Access Compliance Report

Public Rights-of-Way

Intersection ID: 31711	Main Street: WEEPING FIG LN	Cross Street: BLUE ASH LN	Location: E
ADA ID: 706A4C2F2A54	Ramp Type: PerpDiag	Initial Pass/Fail: Fail	Overall Compliance: No
Severity Score: 33.75			
Codes/Mitigation Info/Possible Solution		Field Measurements/Component Compliance

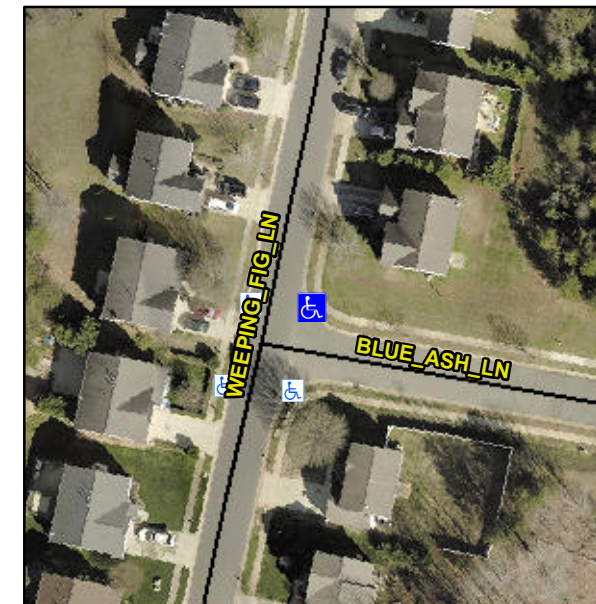
Not Found, R304.5.1, R304.2.2, R304.5.3

Compliance	Description	Data	Compliance	Description	Data
N/A	Ramp Length (in)	47.0	No	Ramp Slope (%)	9.9
No	Ramp Width (in)	39.0	No	Ramp XSlope (%)	6.0
N/A	Flare Type LT	N/A	N/A	Flare Type RT	N/A
N/A	Flare Slope LT (%)	N/A	N/A	Flare Slope RT (%)	N/A
N/A	Flare Traversable LT?	N/A	N/A	Flare Traversable RT?	N/A
N/A	Landing Length (in)	N/A	N/A	DWS Provided?	N/A
N/A	Landing Width (in)	N/A	N/A	DWS Contrast?	N/A
N/A	Landing Slope (%)	N/A	N/A	DWS Length (in)	N/A
N/A	Landing X Slope (%)	N/A	N/A	DWS Full Width?	N/A
N/A	Landing Curb? (Y/N)	N/A	N/A	DWS Offset (in)	N/A
N/A	Shared Landing?	N/A			
N/A	Gutter Ponding?	N/A	N/A	Gutter Slope (%)	N/A
N/A	Gutter Lip Ht (in)	0.5	N/A	Gutter X Slope (%)	N/A
N/A	Painted X Walk1?	No	N/A	Painted X Walk2?	No
	X Walk 1 Direction	To NW		X Walk 2 Direction	To SW
N/A	X Walk 1 Width (in)	N/A	N/A	X Walk 2 Width (in)	N/A
	X Walk 1 Slope (%)	2.2		X Walk 2 Slope (%)	6.3
	X Walk 1 X Slope (%)	5.1		X Walk 2 X Slope (%)	3.0

N/A	Ramp inside XWalk1?	N/A	N/A	Ramp inside XWalk2?	N/A
	Road Slope (%)	4.3	N/A	Clear Space?	N/A
	Road X Slope (%)	2.4	N/A	Clear Space to XWalk (in)	N/A
N/A	Any Obstructions?	N/A	N/A	Storm Grate/Utility Hazard?	N/A
	Obstruction Type			Storm Grate/Utility Type	
		N/A			N/A
			Yes	Surface Condition? (G/P)	Good

Remove & Replace Curb Ramp With Two New Directional Ramps or Equivalent.
